**STAG BREWERY, MORTLAKE
ILLUSTRATIVE HIGHWAY LAYOUT
LOWER RICHMOND RD/MORTLAKE HIGH ST**

Appendix H TfL Modelling Expectations Report

Modelling
Expectations
Document

Job Name: Stag Brewery, Mortlake
Job No: 38262 (draft final)
Note No: 036
Date: 20th April 2020
Prepared by: George Daugherty and Siddharth Iyer
Reviewed by: Peter Wadey and Greg Callaghan
Subject: **Response to the TfL Modelling Expectation Report (11th March 2020)**

Figure 1: Study area

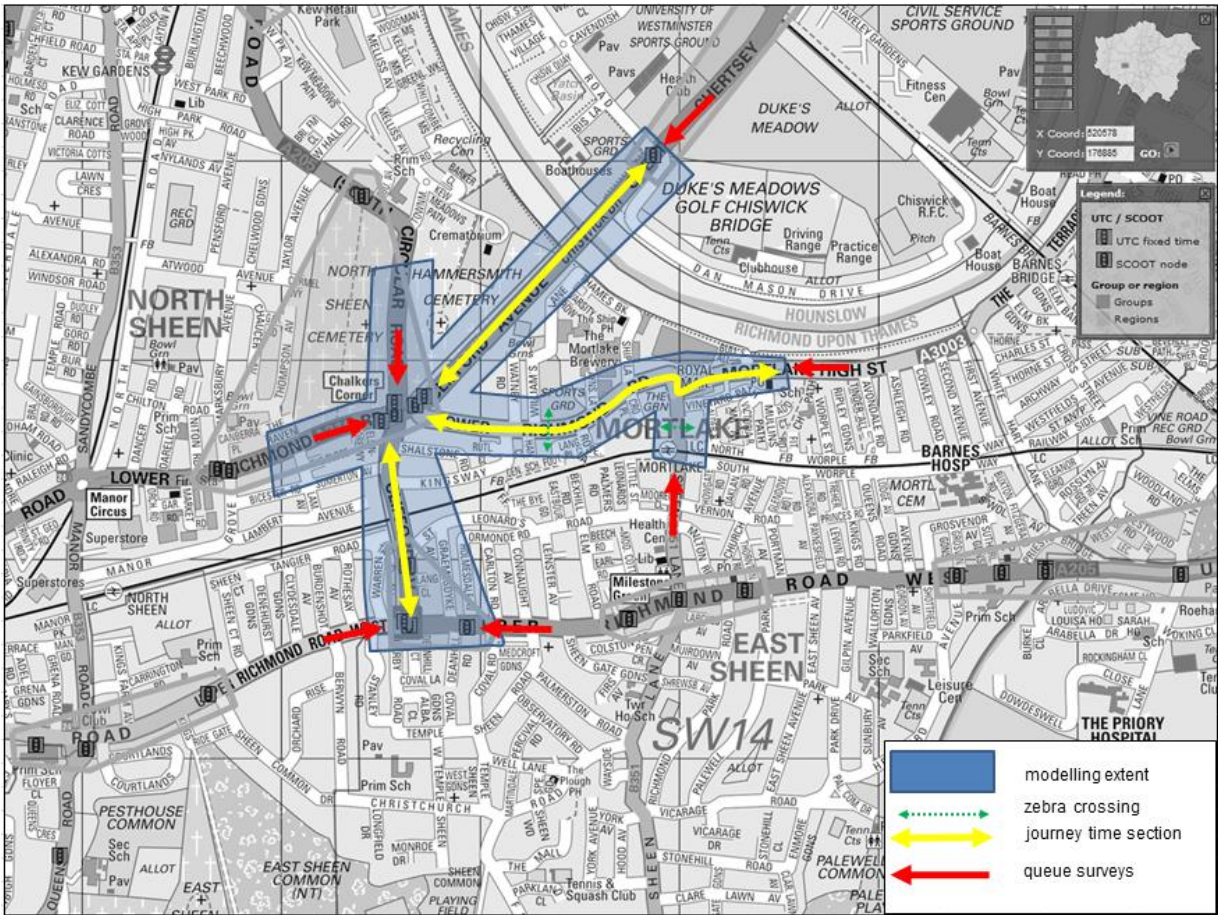
As discussed with TfL Network Performance team the study area must include SCOOT region R278 (Chalkers Corner) as well as R578 (Clifton Avenue/ Upper Richmond Road) and partially R620 (A316 Chertsey Road) as shown on the figure below (Figure 1). At present it is expected that following signalised junction within the required SCOOT regions:

- 24/011 & 24/201 & 24/202 - A205 CLIFFORD AVENUE - A205 MORTLAKE RD - A316 LOWER RICHMOND ROAD - CHALKERS CORNER;
- 24/199 & 24/200) - (A316 CLIFFORD AVENUE - A3003 LOWER RICHMOND ROAD - CHALKERS CORNER)
- 25/068 - GREAT CHERTSEY ROAD - HARTINGTON ROAD - DAN MASON WAY
- 24/147 - A205 CLIFFORD AVENUE BY TANGIER ROAD (NEARSIDE TOUCAN)
- 24/004 - A205 UPPER RICHMOND ROAD WEST - A205 CLIFFORD AVENUE
- 24/215 - A205 UPPER RICHMOND ROAD BY DEANHILL ROAD BY GRAEMESDYKE AVENUE

If necessary, entry links should be extended so that all vehicles can enter the network and consideration should be given to whether the proposal might increase queuing. The links should be long enough so that a journey time marker can be placed beyond the back of the queue in both base and proposed models.

The following sets out why it is felt the model extents should be reduced to cover only Chalkers Corner junction and its immediate approaches from A205 Mortlake Road, A316 Clifford Avenue (North), Lower Richmond Road, A205 Clifford Avenue (South) and A316 Lower Richmond Road. This will include the Lower Richmond Road junctions with Ship Lane, Williams Lane, the Mortlake roundabout and the new development accesses.

The above assessment has informed our view of which junctions can be reliably modelled in VISSIM and in turn provide a response to the MED. The conclusion is that the model extents should include Chalkers Corner and all approach routes with the A3003 Lower Richmond Road extended back along the development frontage into Mortlake High Street to incorporate all the development access points. The adjacent junctions on the A316 (Hartington Road) and A205 (Upper Richmond Road) should be excluded. See Figure 7.

Figure 2: MED Study Area

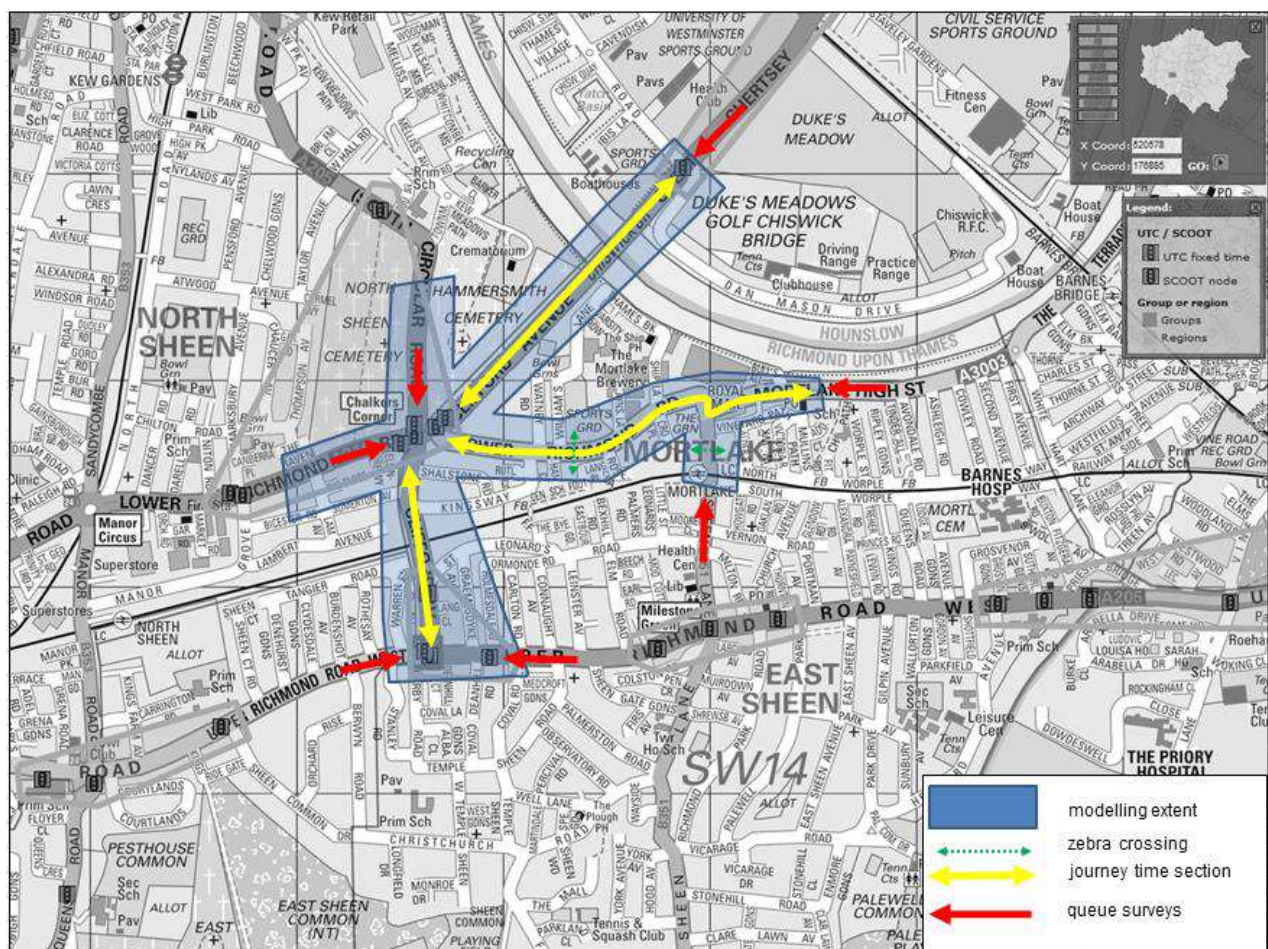
The proposed study area is provided in Figure 2 taken from the MED report.

Furthermore, the MED states 'If necessary, entry links should be extended so that all vehicles can enter the network and consideration should be given to whether the proposal might increase queuing. The links should be long enough so that a journey time marker can be placed beyond the back of the queue in both base and proposed models.'

The justification for including the above junctions is not clear but the MED states it is based on discussions with TfL Network Performance team that confirm the ‘study area must include SCOOT region R278 (Chalkers Corner) as well as R578 (Clifton Avenue/ Upper Richmond Road) and partially R620 (A316 Chertsey Road)’.

Table 2: Percentage trip distribution across local junctions

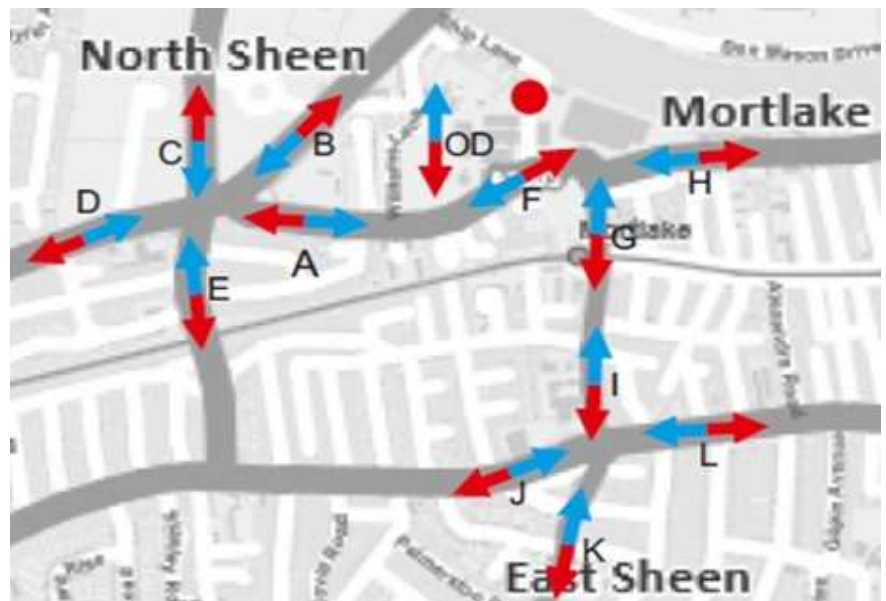
The percent of development trips passing through this junction (i.e. arrow B) in the northbound direction (red) is 16% (AM) and 8% (PM) and in the southbound direction (blue) 11% (AM) and 33% (PM). This reflects tidal commuter flows and based on current but unconfirmed development trips, would result in an increase of between 9 to 27 car trips in the peak hour.

An ATC survey undertaken in 2017 shows the peak hourly traffic flows along this section of the A316 Great Chertsey Road ranges from 965 to 1,417 vehicles per hour giving a 0.7% to 2.3% increase in traffic as a result of the development (Table 3).

When these 'Development Trips' are compared with the 'Traffic Flow' standard deviation for peak hour traffic flows along the A316, it is clear the increase is well within normal day to day variability.

For this reason, the A316 Great Chertsey Road j/w Hartington Road and Dan Mason Way should not be included in the modelled network.

Figure 3: Upper Richmond Road j/w Clifford Avenue (AM development trip distribution)

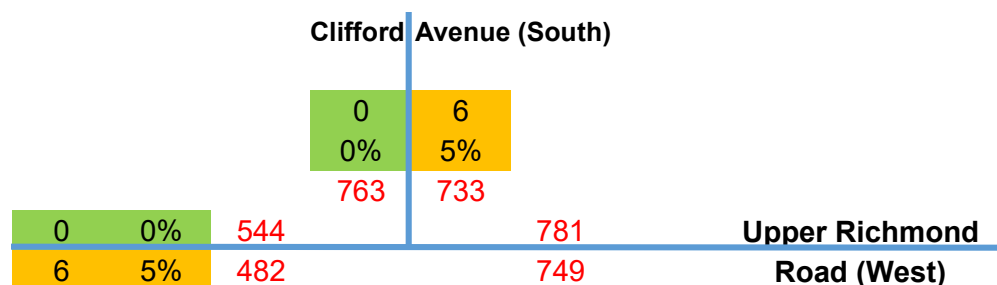
As part of the A205 South Circular, this congested junction suffers exit blocking as a result of traffic queuing back from Chalkers Corner. Google traffic suggests this can result in a queue extending back along A205 Upper Richmond Road and through the junction with Sheen Lane. As suggested previously, this situation is likely to have worsened considerably since the closure of Hammersmith Bridge and that the scope to improve the operation of the junction is very limited.

Trips generated by the development and forecast to travel through this junction are low. Arrows E and J in Table 2 suggests no development trips approach the junction from the east (J) and that only 5% (AM) to 8% (PM) approach the junction from the north (A205 Clifford Avenue) and west (A305 Upper Richmond Road). Based on current development trip estimates, this would add 6 and 10 car trips to the AM and PM peak hours respectively making the right turn from Clifford Avenue into Upper Richmond Road and visa versa. This is summarised in Figure 3 and Figure 4 where the Green and Yellow boxes show the distribution of development trips (number and percentage) with the peak hourly flow shown in red text.

For these reasons, the A205 Upper Richmond Road j/w A205 Clifford Avenue (South) should not be included within the modelled network.

Figure 5: Upper Richmond Road j/w Sheen Lane (AM development trip distribution)

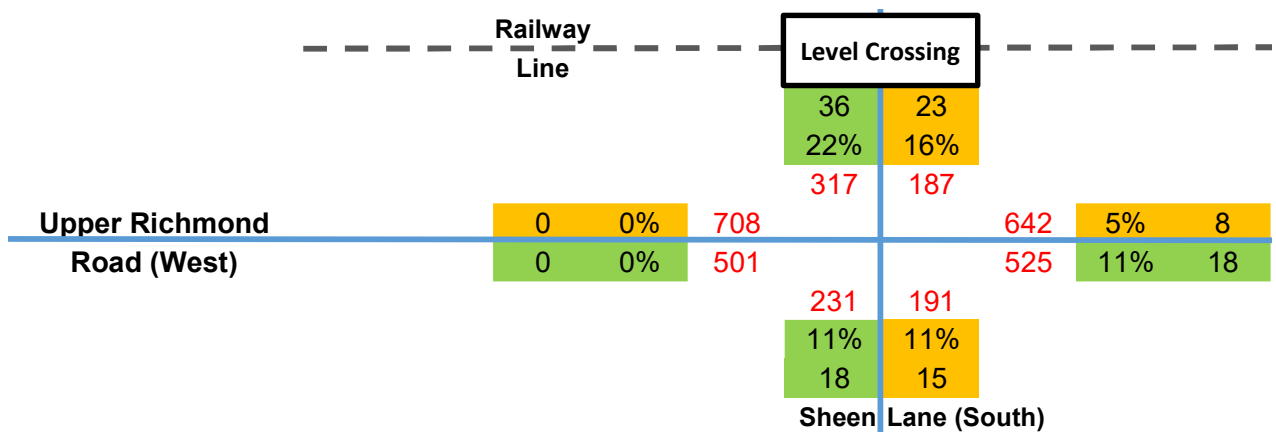
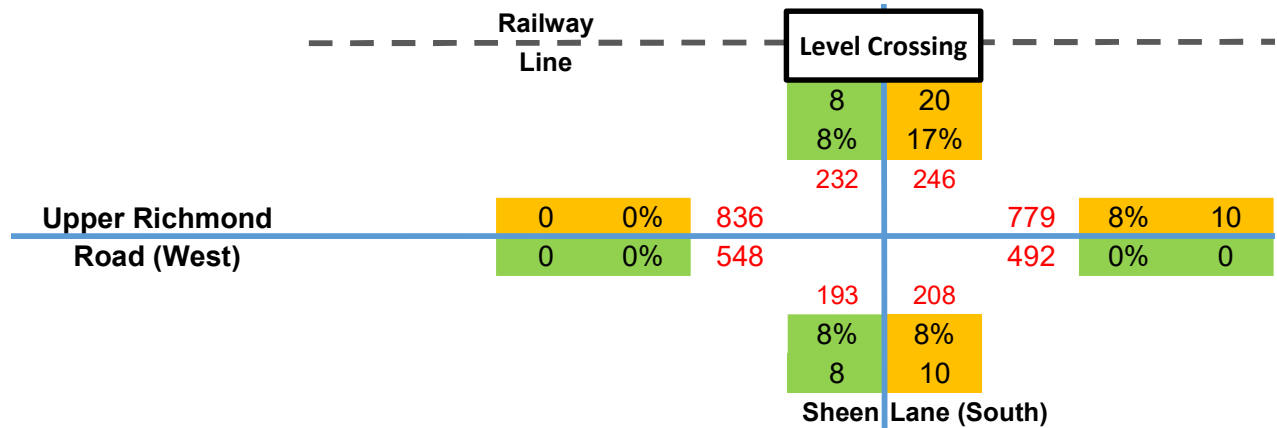
Although this junction is not included in the MED the same issues described above for the Upper Richmond Road j/w Clifford Avenue (South) apply. As shown in Figure 5 and Figure 6 the development trips are slightly higher at this junction but they are still only a small proportion of the peak hourly flows approaching the junction from the A205 Upper Richmond Road.

For this reason, the A205 Upper Richmond Road j/w Sheen Lane should not be included within the modelled network.
